**TOWN OF MOUNTAIN VILLAGE  
SPECIAL DESIGN REVIEW BOARD MEETING AGENDA  
THURSDAY MAY 23, 2024, 10:00 AM  
MOUNTAIN VILLAGE TOWN HALL  
455 MOUNTAIN VILLAGE BLVD, MOUNTAIN VILLAGE, COLORADO  
TO BE HELD HYBRID THROUGH ZOOM:  
<https://us06web.zoom.us/j/88529088920>  
Meeting ID: 885 2908 8920**

**TO:** Mountain Village Design Review Board  
**FROM:** Drew Nelson, Senior Planner  
**FOR:** Design Review Board Public Hearing; May 23, 2024  
**DATE:** May 16, 2024  
**RE:** Staff Memo – Final Architecture Review (FAR) Lot 160R and Lot 1005R Pursuant to the CDC

**APPLICATION OVERVIEW: New Bus Stop on Lot 160R and Lot 1005R**

# BUS STOP & SHELTER (VCA)

ELEVATIONS

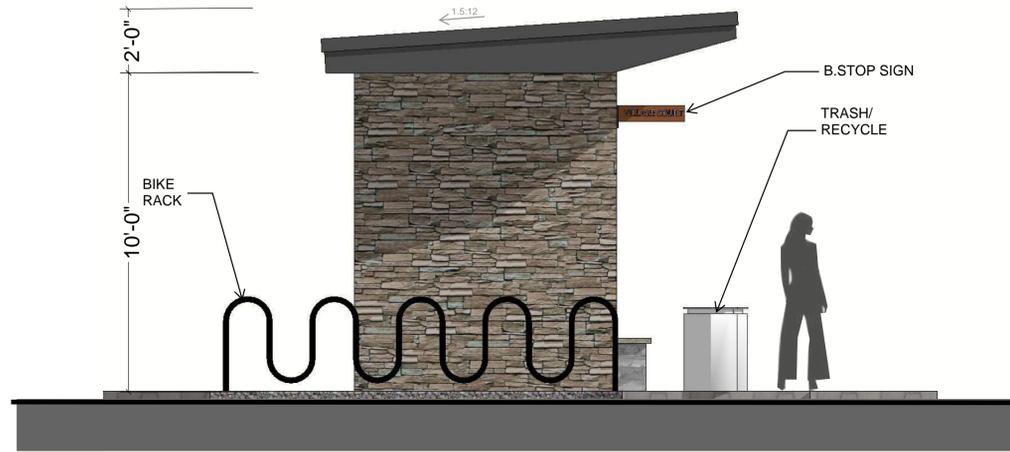
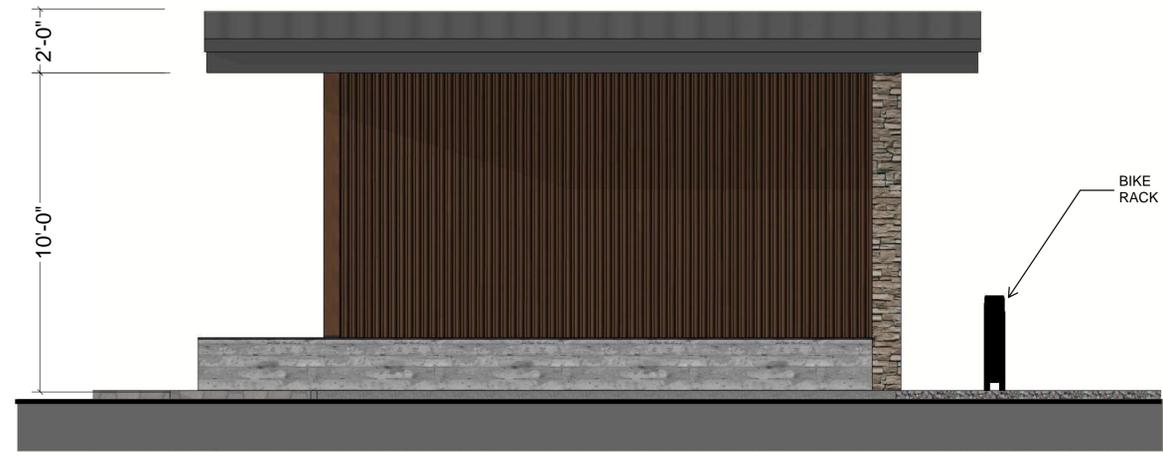
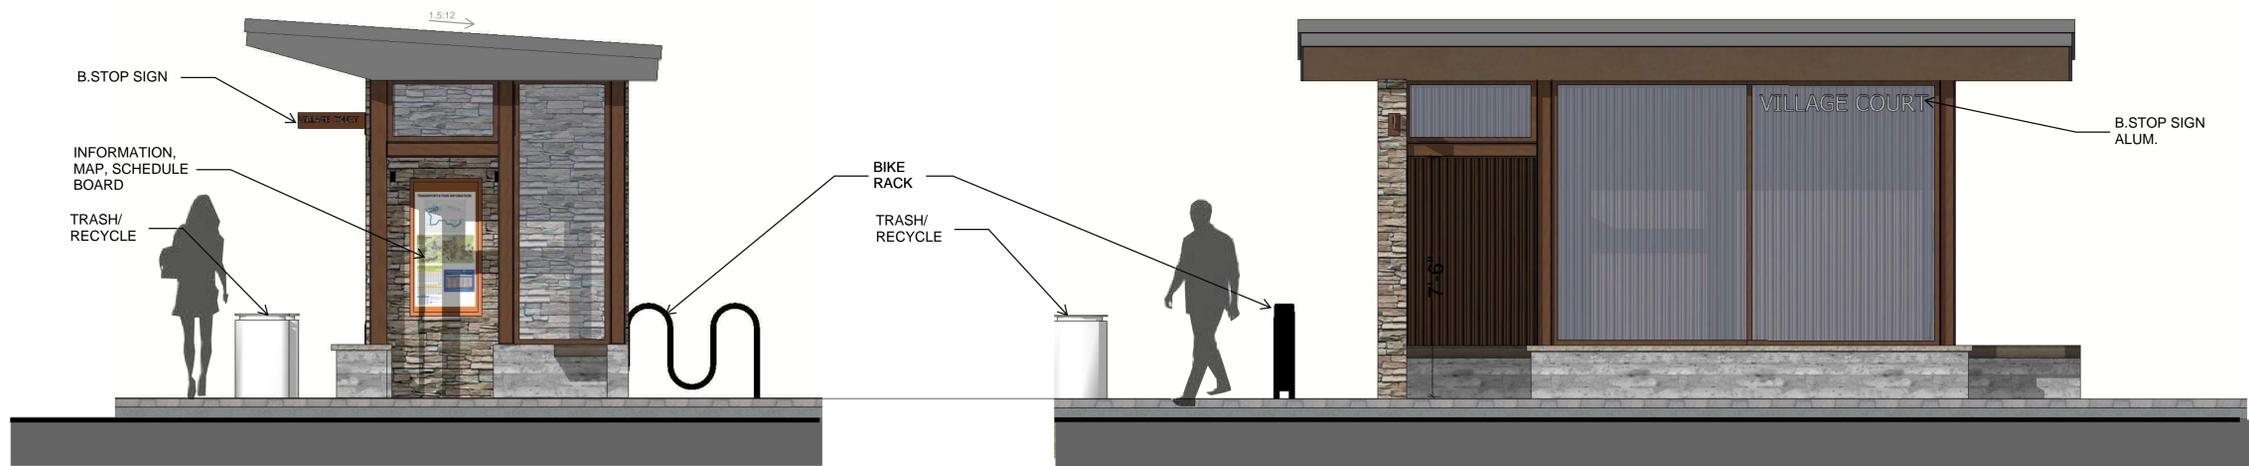
*Staff: The primary roof form of the proposed structure is flat, with a slight pitch from front to back, and is therefore granted a maximum height of 48 feet and an average height of 48 feet. The applicant has indicated that the maximum height of the current proposed structure is 11.5 feet and has an average height of 11.5 feet (Sheet A-300 of the attached plan set). The building height meets the requirements of the CDC.*

*The building utilizes stone, boardform concrete, metal, and glass windows for the majority of the exterior walls, with stone now making up the majority of the western wall that faces Mountain Village Boulevard. The stone accounts for 15.17% of the total building form, requiring a design variation from the DRB. In addition, the use of boardform concrete requires a specific approval from the DRB. It should be noted that in certain locations (most notably at the Blue Mesa stop), noncombustible materials must be used due requirements of the Colorado Tramway Board for structures within a certain distance of overhead lift/gondola cables.*

*The maximum window area of the building, including window and door glazing, is approximately 32.34% of the total building façade. It should be noted that there are no doors proposed for the structure. If glass doors were proposed, the amount of window and door glazing would exceed the 40% limits of the CDC.*
